95460021-WSE One belt cutter deck

The **71460115** kit is for changing out the 71460038, 57 and 92 spindles used in the WSR/WSES/WZ/WSE models. The new 71460134 spindle bolts directly into the cutter deck (no spacer is needed) and uses the 71460111 tapered bushing and 11990090 bolts. Two 13990007 blades spacers are used between the blade and spindle to position the blade correctly and the 11990116 bolt and 13990039 washer are used to secure the blade. Torque blade bolt to between 70 – 80 ftlbs.

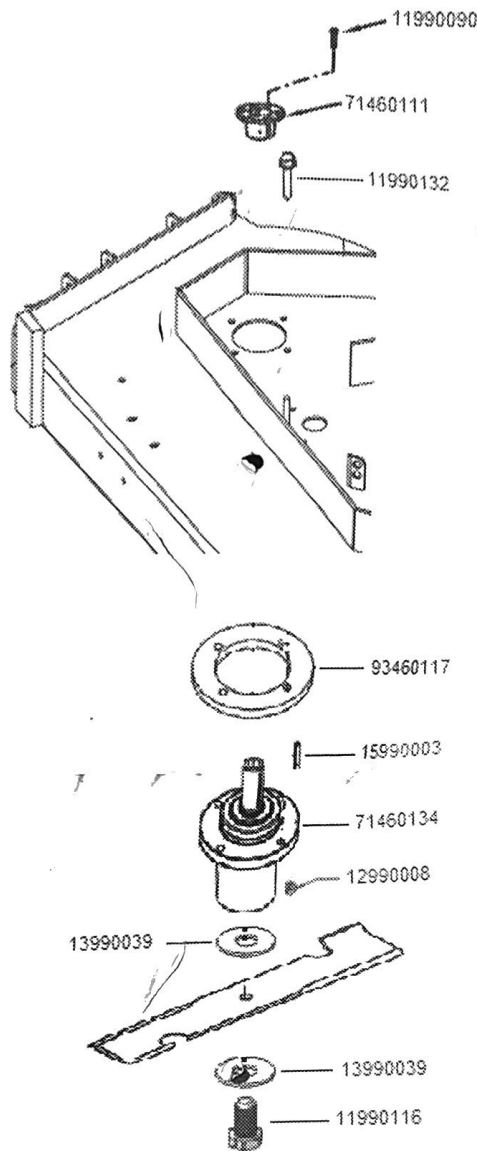
Mounts from bottom of deck.
Replaces 71460026, 38 and 57
Torque blade bolt to between 70 – 80 ftlbs.
